Bulletin No:	B408CRM115-0
Release Date:	May 9, 2003
Effective Date:	Immediately
Supersedes:	B408CRM110-0
Completion Date:	N/A
Page:	1 of 4

SERVICE BULLETIN

Ride Name: CHAOS

Abstract of Issue:
Sweep Inspection

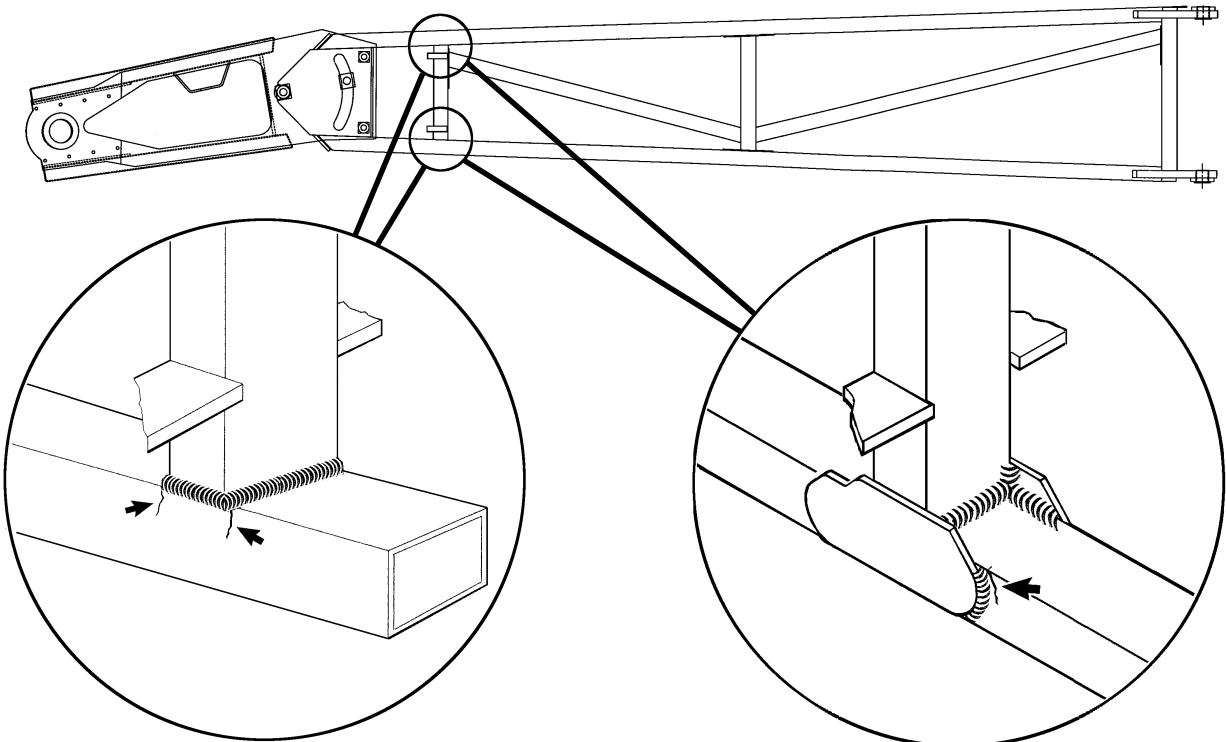
Visually inspect every sweep for cracks as shown in the illustration on the next page, paying particular attention to the areas indicated by arrows. Look for indications in the steel tubes, and check the welded joints for indications in the welds and the parent metal.

Pay particular attention to this area on both the top and bottom tubes of each sweep.

Perform this inspection WEEKLY.

IF NO INDICATIONS ARE FOUND, the ride can be operated normally. The sweeps must be inspected weekly as described in this bulletin.

IF ANY INDICATIONS ARE FOUND, do not operate the ride. Contact the Customer Service Department at Chance Rides Manufacturing, Inc. immediately for instructions on the necessary repair procedure. The repair will include the installation of the Sweep Reinforcement Kit (number K408CRM115-0), as well as specific instructions for repairing cracks.

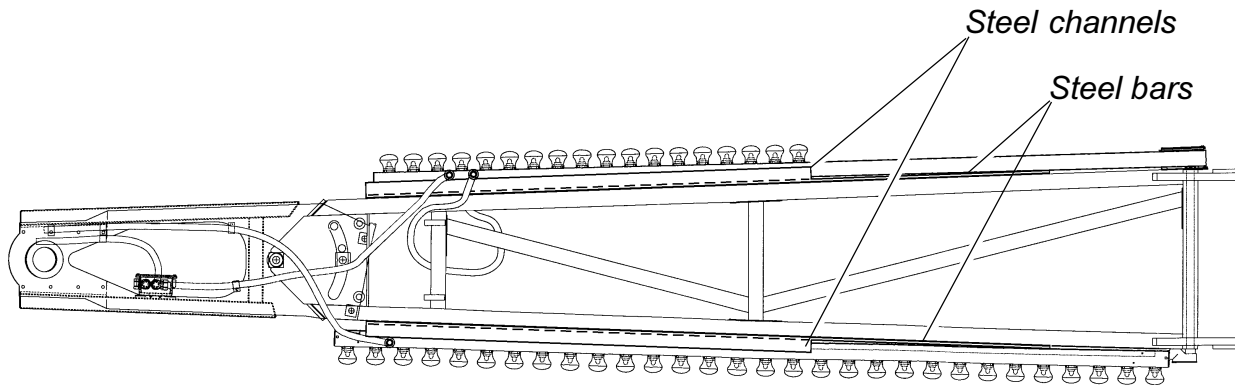
Installation of the Sweep Reinforcement Kit (K408CRM115-0) can be visually verified by the channels and bars welded to the upper and lower tubes of every sweep as shown.

On rides with the Sweep Reinforcement Kit installed, perform the inspection described in this bulletin ANNUALLY.
